Project/File: Fort St. James Arena Upgrade
Addendum No.: 2
Date: November 15, 2024
To: All Proponents
RFP No.: RFP2024-005

APPENDIX D – Project Drawings:

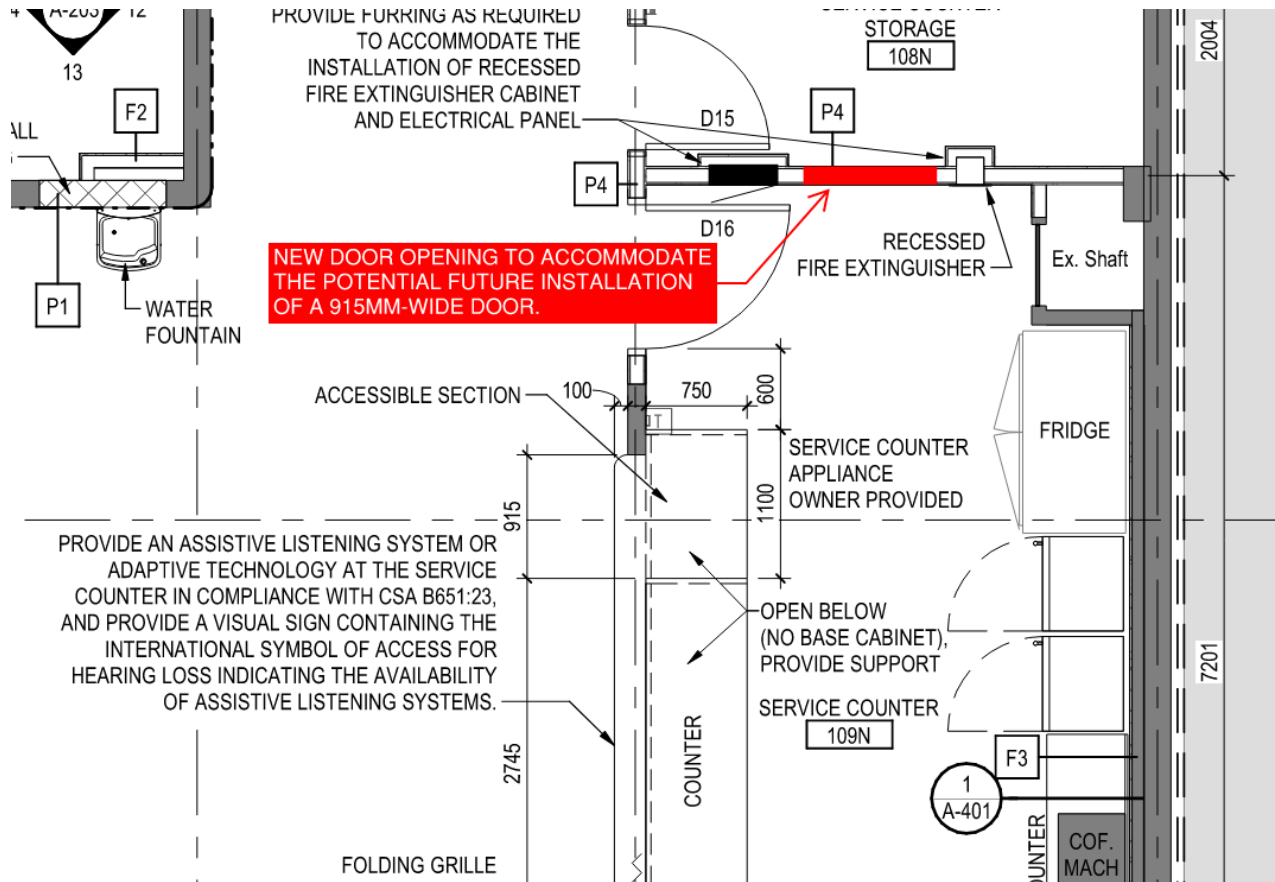
1. Architectural
 - 1.1. Add a new door opening in the partition between Room 108N (Service Counter Storage) and Room 109N (Service Counter). Frame opening to accommodate the potential future installation of a 915mm-wide door.
